Formal Objection Letter: Harcourt House Energy Strategy Review and Non-Compliance

Development at Harcourt House N8 9JB
Planning application reference: HGY/2024/0921

Document Ref: JF458-RP-Z-0001 dated 6th August 2024

Figure 1 MCS Shading Factor Calculation for objects closer than 10m

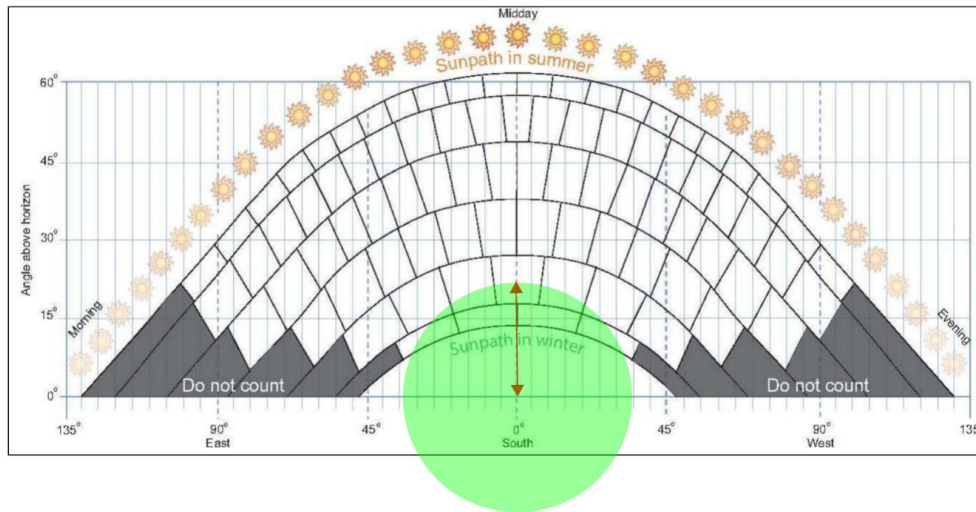
The Energy Statement cites a 3.8 kWp solar PV array composed of 10 panels. However, the submitted roof plan drawing (CF-214-DR-1140-C) shows only 9 panels. While the 3.8 kWp capacity is technically achievable using high-efficiency panels, the claimed annual generation figure of 3,279.40 kWh is not credible based on standard MCS estimation methods.

- Installed capacity (kWp) = 3.8
- Performance factor (Kk) = 766 (based on an 8° tilt and 160° deviation from south)
- Shading factor (SF) = 0.91

This results in an estimated annual output of 2,649 kWh, which is **19% lower than stated in the Energy Statement**.

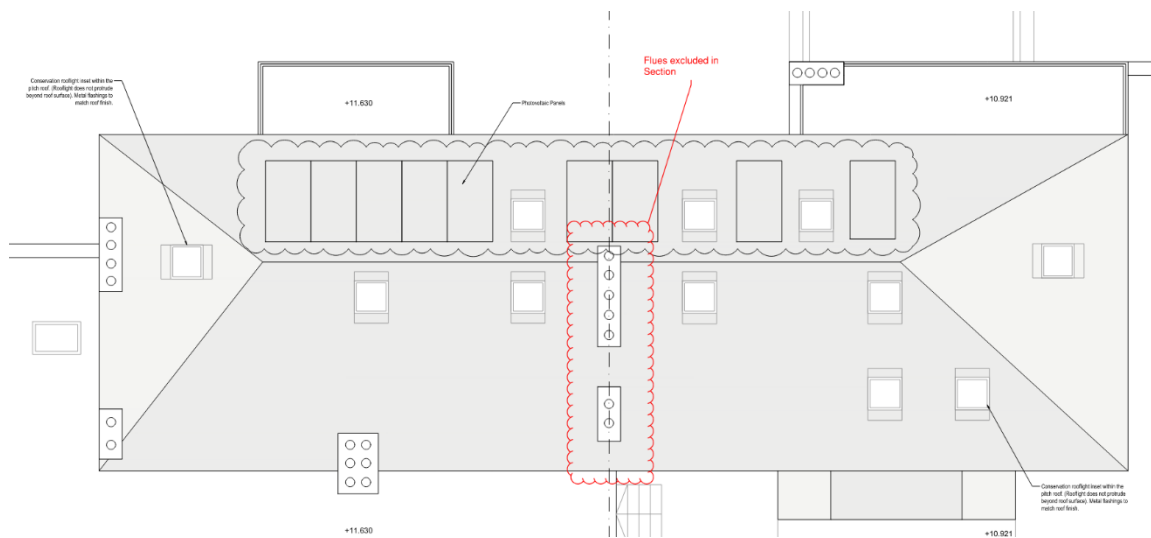
- The calculation of carbon savings is based on an outdated electricity carbon factor of 0.232 kgCO₂/kWh, rather than the current SAP 10.2 factor of 0.136 kgCO₂e/kWh. This materially overstates the environmental benefit of the system.
- The Energy Statement provides no evidence that the solar PV system has been designed to align with on-site demand profiles (i.e. demand-side response). Nor does it address battery storage, which is a key consideration for improving on-site renewable energy utilisation and future compliance.
- The panels are proposed at an 8° incline, which is insufficient to ensure self-cleaning by rainfall. This would likely lead to reduced performance over time, unless regular manual cleaning is arranged. No provision for safe access or maintenance has been included.
